Serial Number 10/620,228  
Attorney Docket No. A3-143 US

# Annotated Marked-up Drawings

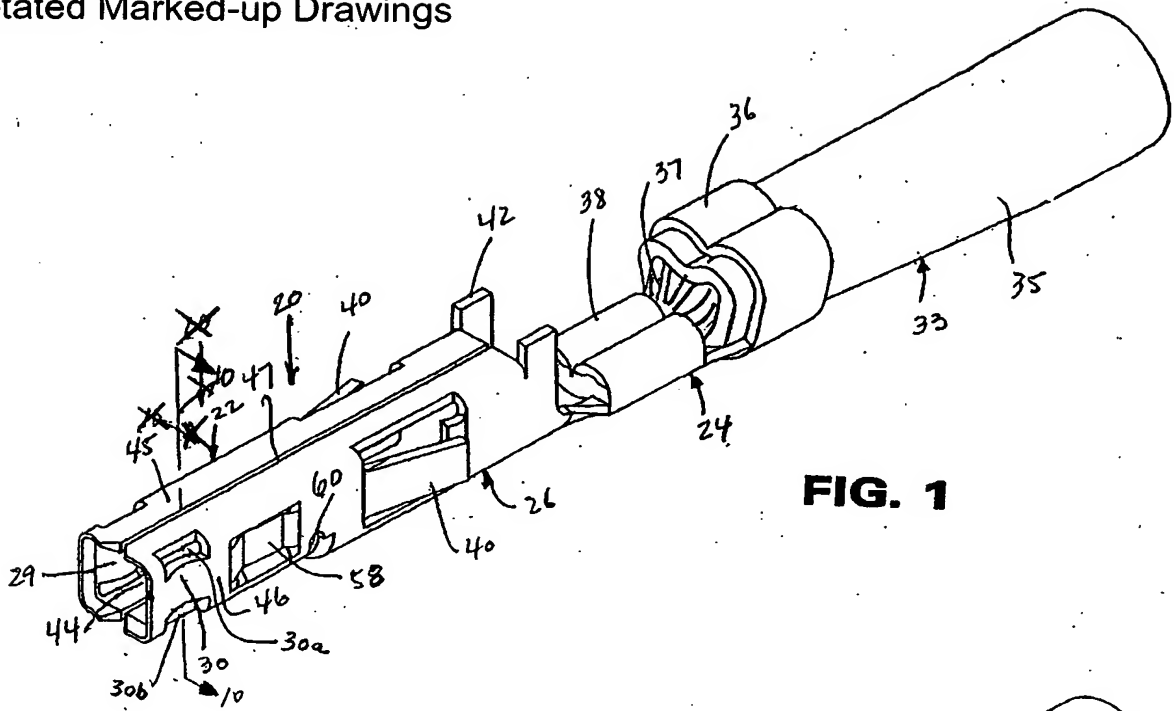
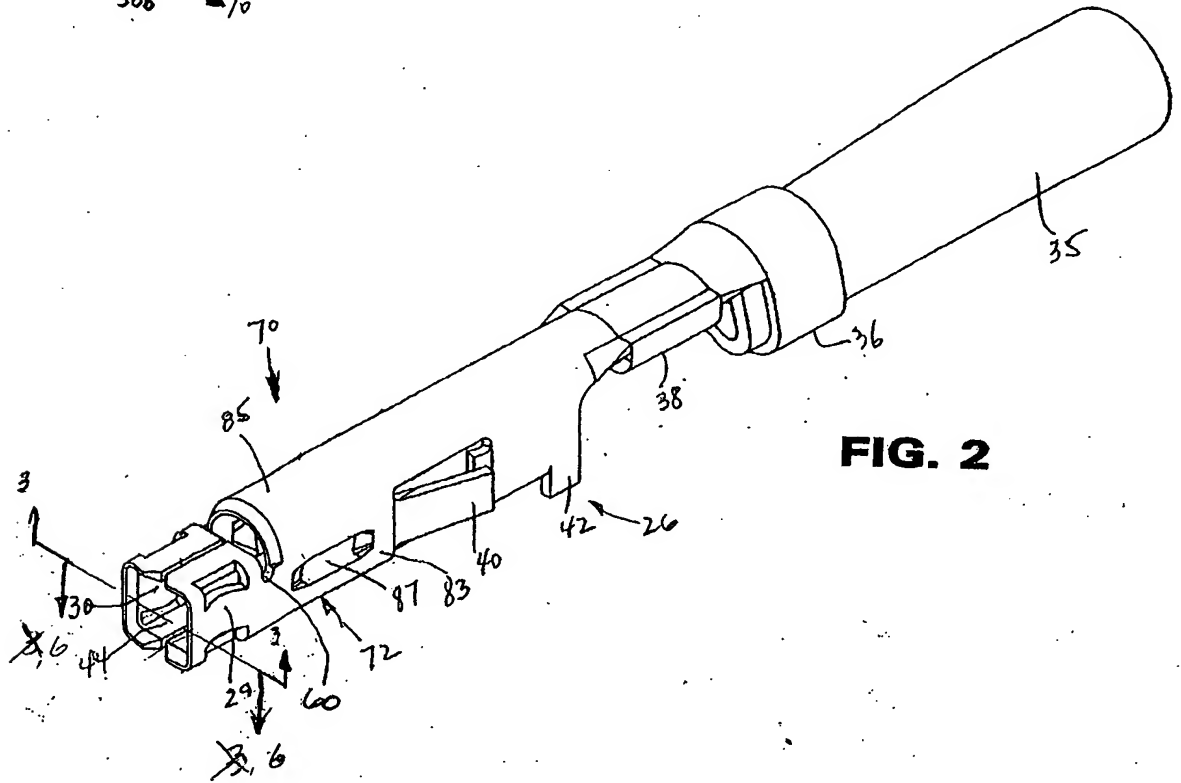
In the Office Action mailed on December 18, 2003, the Examiner objected to some of the drawings as not having proper sectional lines, objected to the abstract as being too long, objected to claims 1, 3, 4, 8, 12, 15, 17, and 26 because of a number of informalities, rejected claims 1-11, 14-25 and 28-31 under 35 U.S.C. section 102 (b) as being anticipated by Chaillot et al. (US 5,989,078), and rejected claims 12, 13, 26, and 27 under 35 U.S.C. section 103 (a) as being an unpatentable combination of Chaillot et al. (US 5,989,078) in view of Ito et al (US 5,630,738).

Attached are two copies of sheet 1 of the drawings. One sheet has the changes highlighted and the other sheet is a clear copy of the drawings as amended which should replace the original sheet 1..

With this amendment sheet one of the drawings has been replaced with a corrected drawing, the abstract has been replaced with a new shortened abstract, and claims 1, 3, 4, 8, 12, 15, 17, and 26 have been amended. Claims 1-31 remain in this application.
